LAND NORTH OF SOLENT ROAD (ADJACENT TO BOSMERE MEDICAL CENTRE), HAVANT.

Planning Ref: APP/21/00601

Consolidated Response to Environment Agency, Portsmouth Water and LLFA

DRAINAGE PLANNING STRATEGY

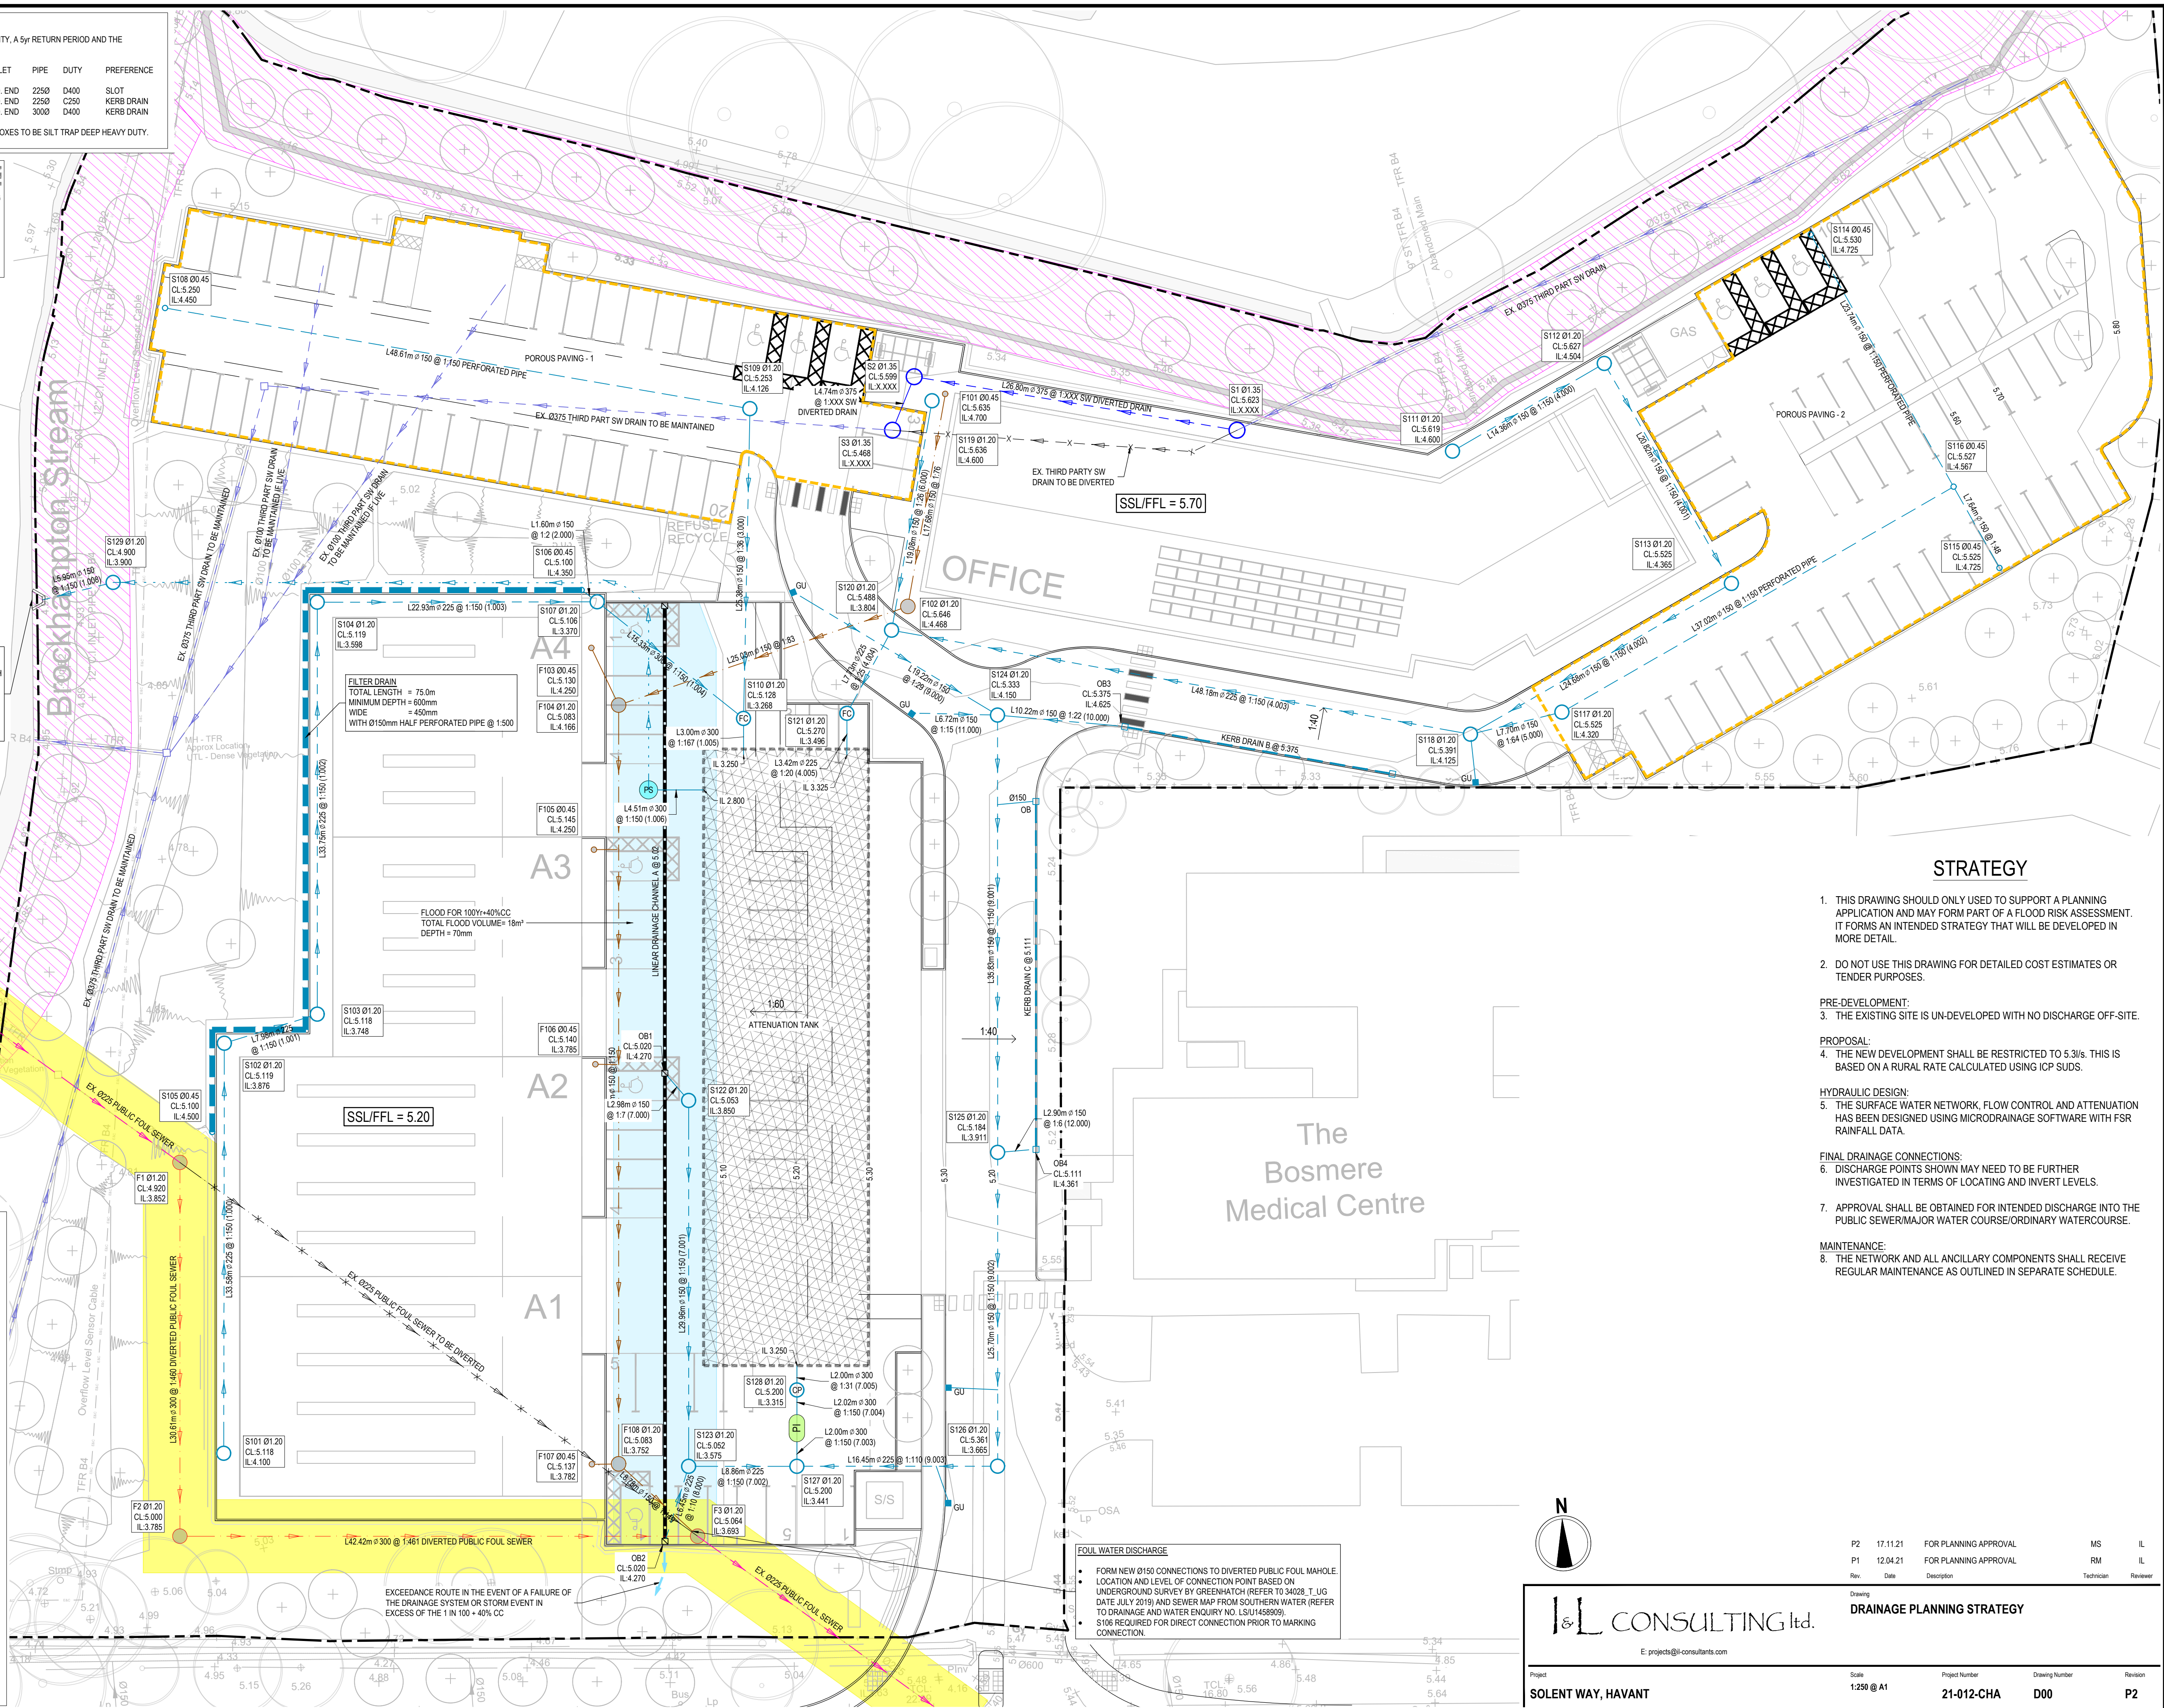
- *Detailed drainage layout drawings at an identified scale indicating catchment areas, referenced drainage features, manhole cover and invert levels and pipe diameters, lengths, and gradients.*

- *Detailed network hydraulic calculations for all rainfall events, including the listed below. The hydraulic calculations should take into account the connectivity of the entire drainage features including the discharge location. The results should include design and simulation criteria, network design and result tables, manholes schedule tables and summary of critical result by maximum level during the 1 in 1, 1 in 30 and 1 in 100 (plus an allowance for climate change) rainfall events. The drainage features should have the same reference that the submitted drainage layout.*

- *Additionally, and since the proposed outfall will be within the fluvial flood extent, the hydraulic calculations should include a surcharged outfall equivalent to the predicted 1 in 100-year flood level showing how that event will be managed safely.*

- *Confirmation that sufficient water quality measures have been included to satisfy the methodology in the Ciria SuDS Manual C753.*

- *Exceedance plans demonstrating the flow paths and areas of ponding in the event of blockages or storms exceeding design criteria.*

Please see **Appendix A** attached which provides requested layout plan along with calculations and comments to address all points raised above.
